**23/01633/F - Site at Calthorpe Street and Marlborough Road Banbury. Demolition of existing retail units and public car park and redevelopment for residential dwellings (C3 Use), provision of private car parking, hard and soft landscaping and photovoltaic (PV) panels on roof, and associated works.**

The Banbury Civic Society wishes to express some grave concerns about the proposed development.

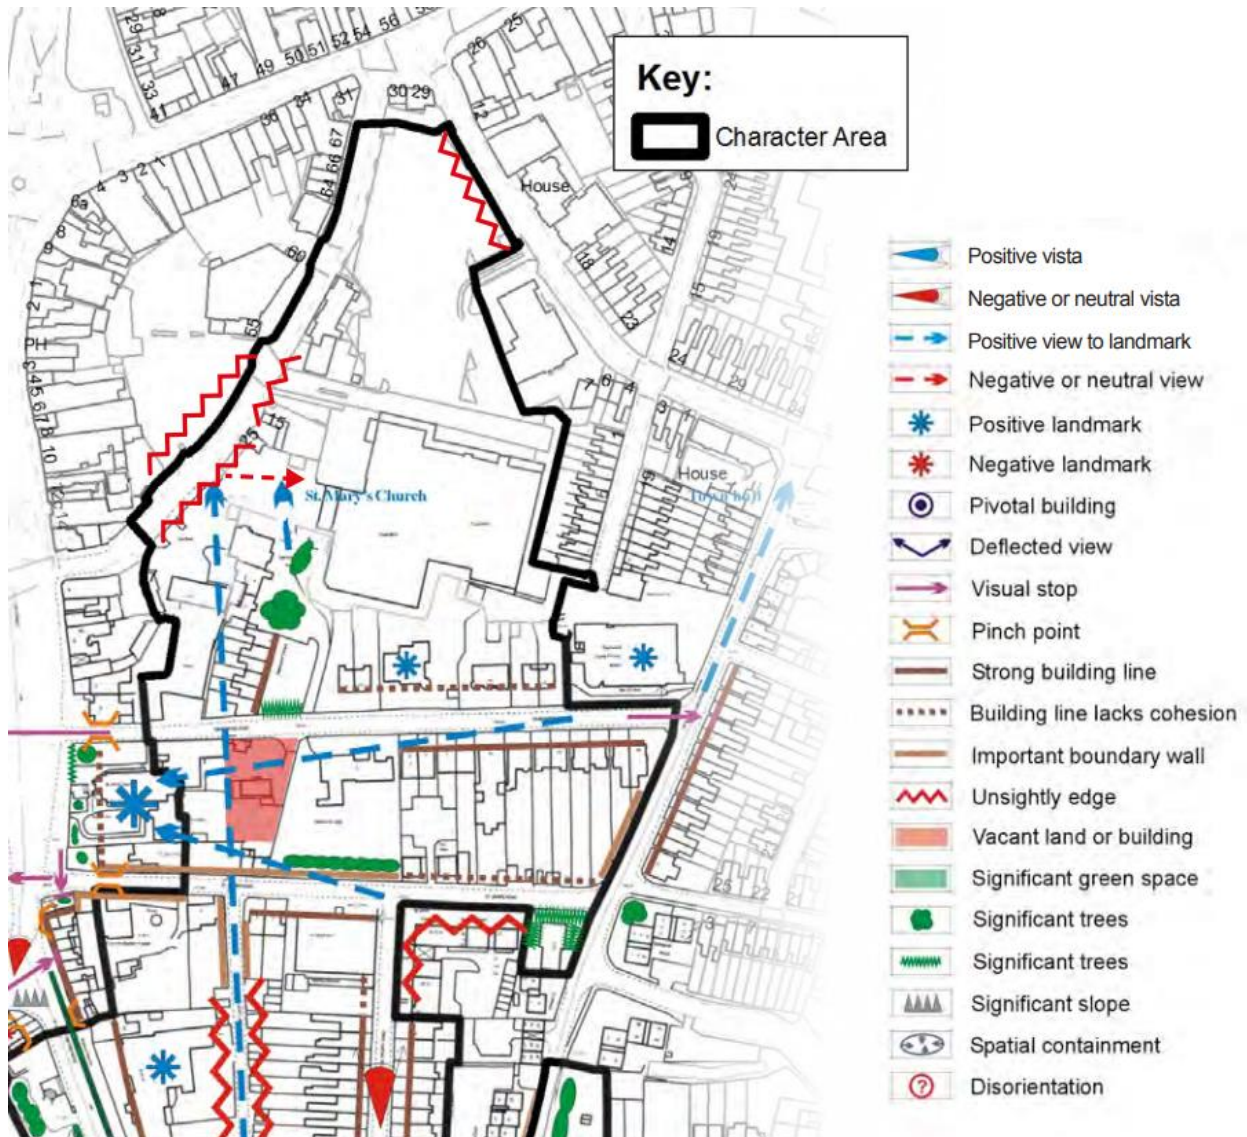
View looking north along Calthorpe Street with the Grade II\* Calthorpe Manor on far right and its locally-listed former gate lodges centre left. If the proposed development is approved and built, almost the whole of this view will be dominated by 4- and 5-storey blocks of flats, resulting in significant harm to the setting of these important historic buildings
